DELAWARE RIVER JOINT TOLL BRIDGE COMMISSION
ADMINISTRATION BUILDING
110 WOOD & GROVE STREETS
MORRISVILLE, PA19067

ADDENDUM NO. 4

This **Addendum No. 4**, dated February 22, 2018, gives additional information in connection with **Contract No. T-707A, Capital Project 1644A, Commission Administration Building at Scudder Falls and Adaptive Reuse of the 1799 Building**, and is hereby made a part of the Contract. This Addendum is to be signed by the Contractor below and this **Page AD4-1** is to be attached to the bid proposal.

1 MOCK UP
SCALE: 1/8" = 1'-0"

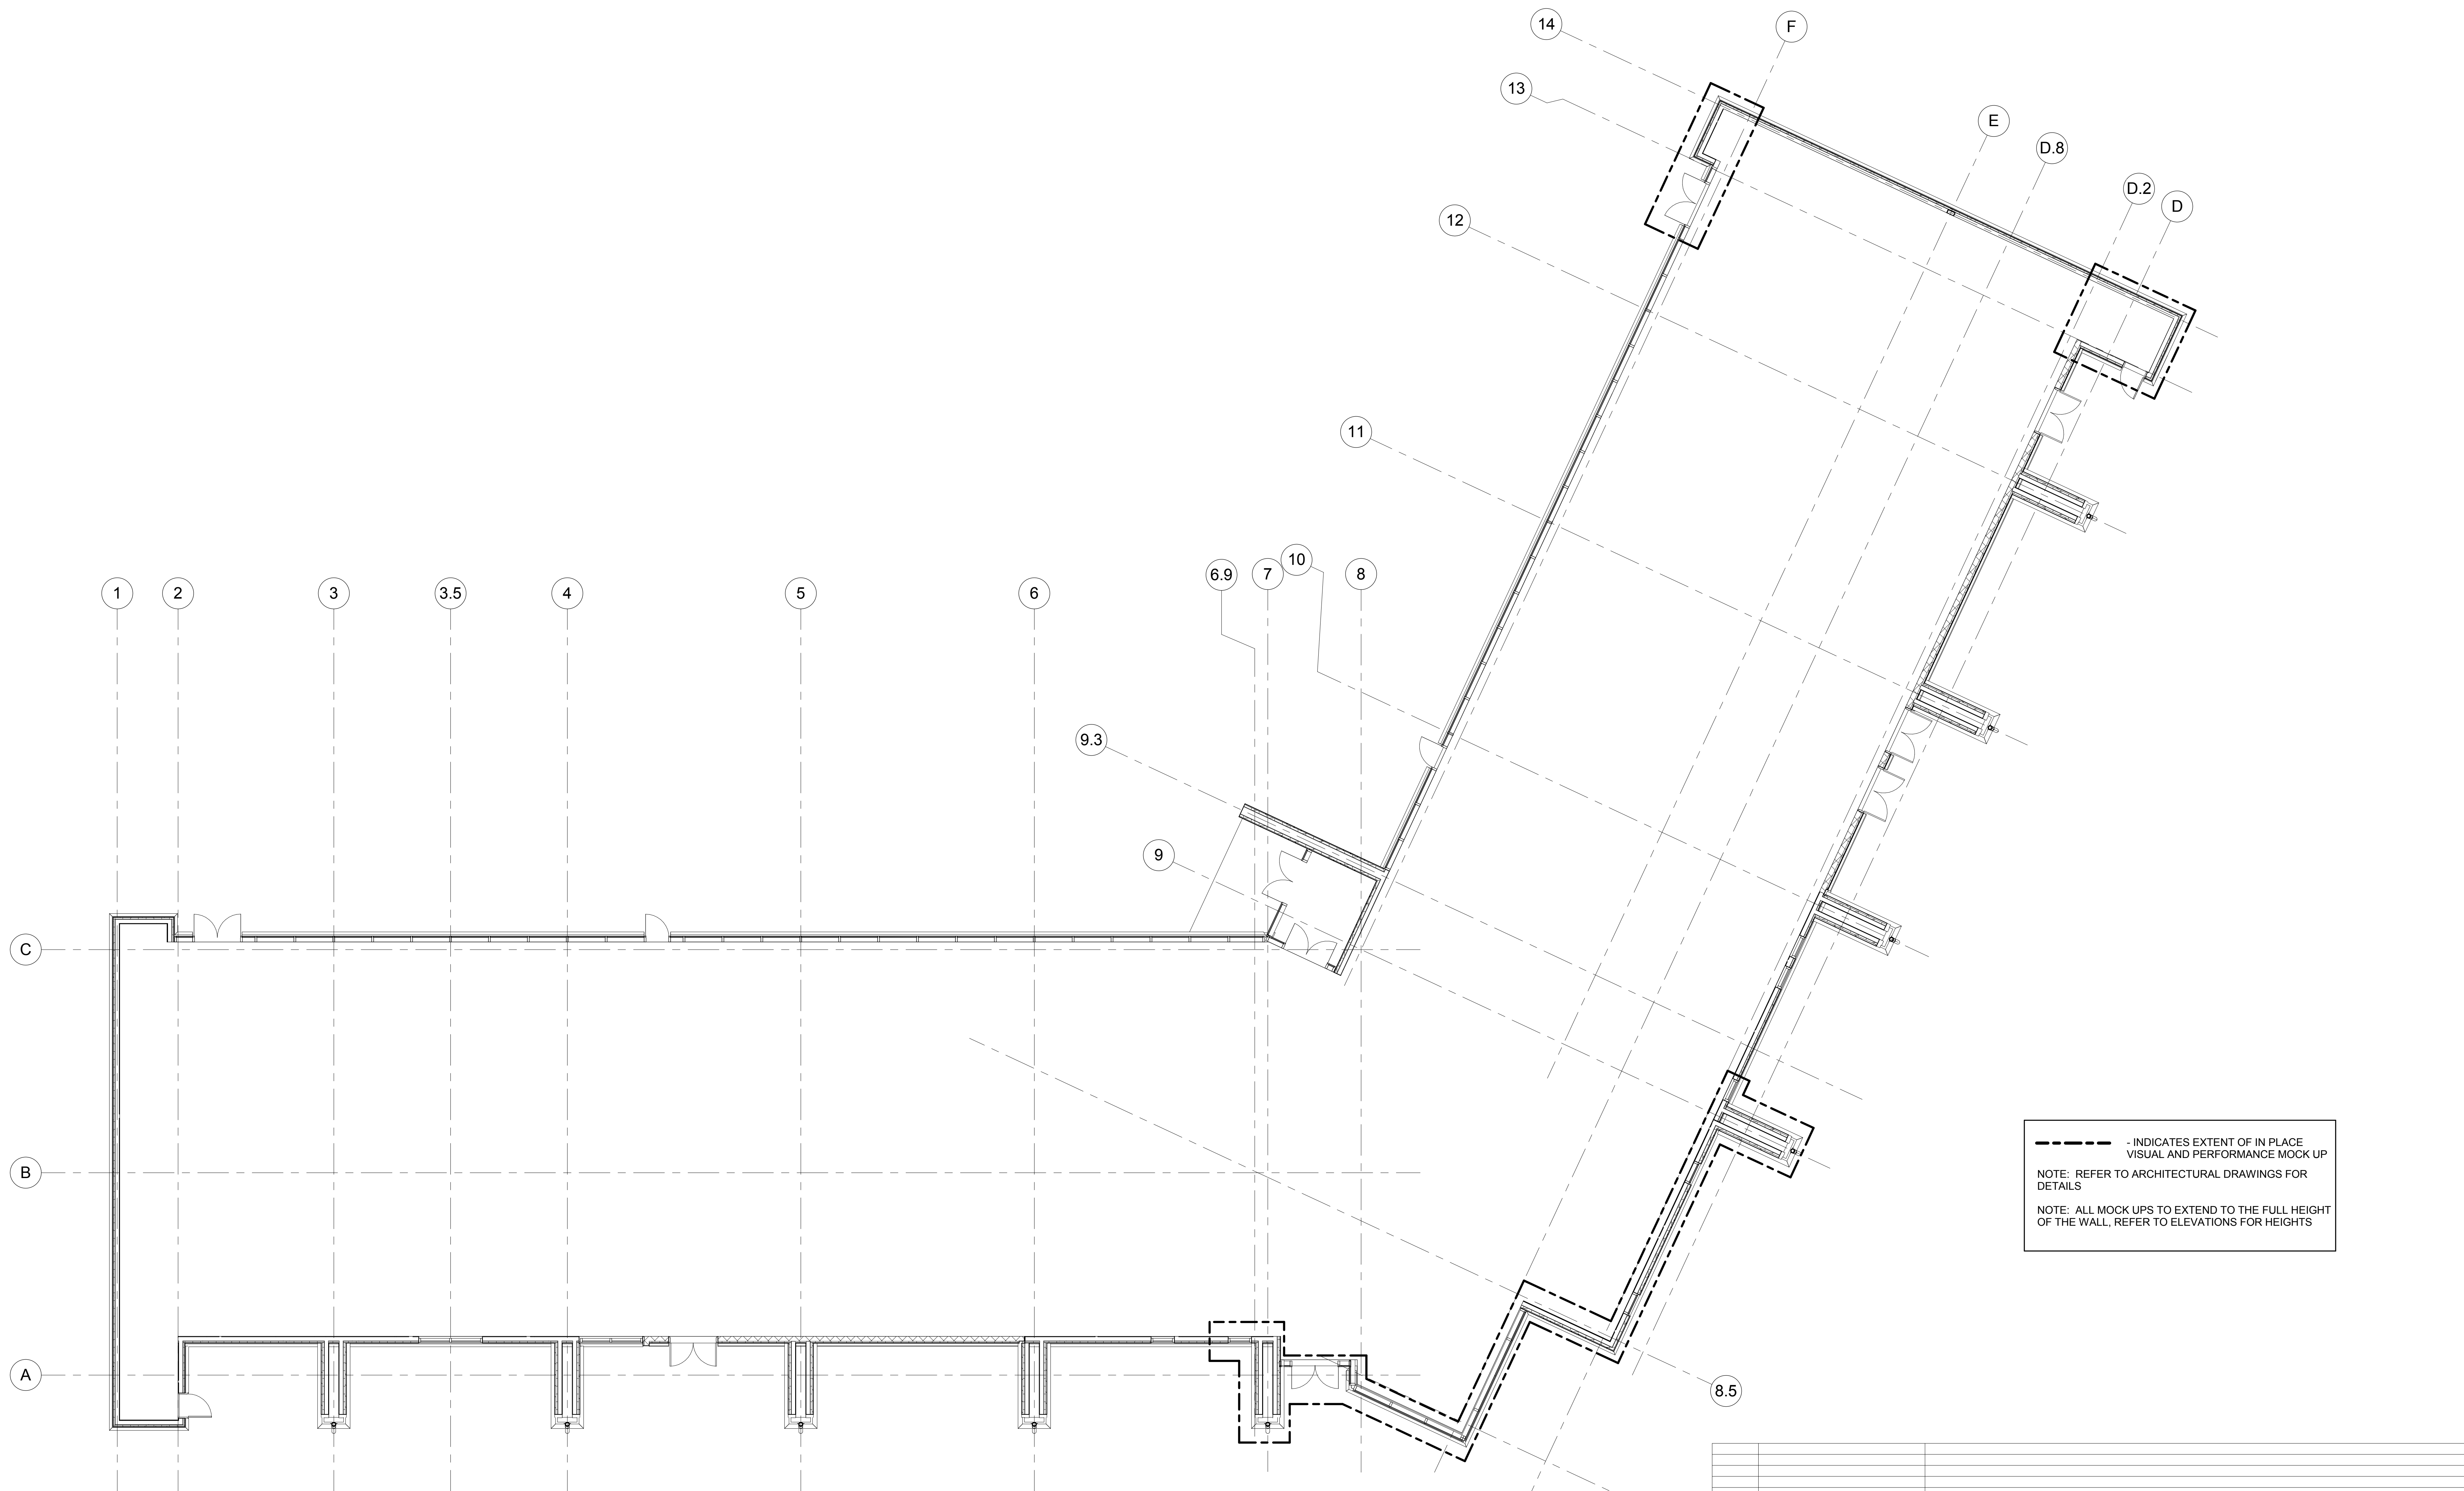
Additionally refer to Drawing A1-900 - In Place Mock-up Drawing, attached herein, for location in plan where the in-place testing of the construction will take place.

--- INDICATES EXTENT OF IN PLACE
VISUAL AND PERFORMANCE MOCK UP
NOTE: REFER TO ARCHITECTURAL DRAWINGS FOR
DETAILS
NOTE: ALL MOCK UPS TO EXTEND TO THE FULL HEIGHT
OF THE WALL, REFER TO ELEVATIONS FOR HEIGHTS
